Southern Nuclear Operating Company  
Vogtle Electric Generating Plant Units 3 and 4  
Request for License Amendment:  
Module Obstructions and Details (LAR-13-006)

**Southern Nuclear Operating Company**  
**Vogtle Electric Generating Plant (VEGP) Units 3 and 4**

**Request for License Amendment Regarding**  
**Module Obstructions and Details**  
**(LAR-13-006)**

**Enclosure 2**

**UFSAR Section 3.8, Figure 3.8.3-8, Sheet 1 of 3, [*Structural Modules – Typical Design Details*]\* - Revise Tier 2\* information in Note 2 to address acceptable spacing and tolerances.**

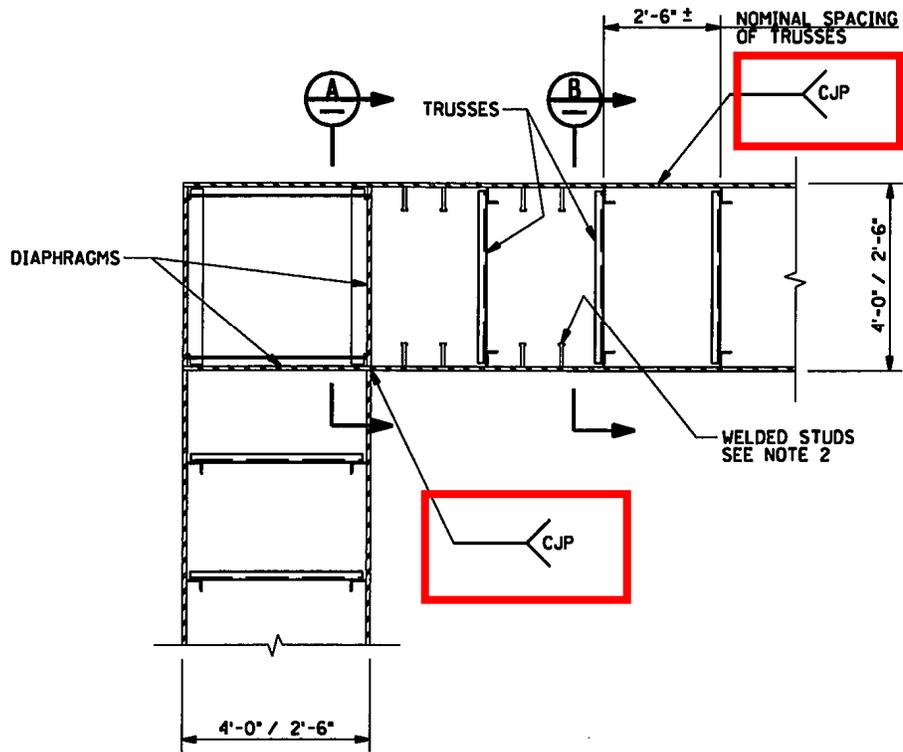
UFSAR Section 3.8, Figure 3.8.3-8, Sheet 1 of 3, [*Structural Modules – Typical Design Details*]\* - Revise Tier 2\* information in the Plan View Detail 1 to change weld symbols currently showing a square groove weld to a symbol indicating a Complete Joint Penetration weld.

2. **DESIGN SPACING FOR WELDED STUDS IS SHALL BE SPACED AS FOLLOWS, UNLESS OTHERWISE REQUIRED BY THE SPECIFIC CODES AND STANDARDS INVOKED:**

**THE TOLERANCE FOR THE SPACING IS  $\pm$  10% OF THE DESIGN SPACING.**
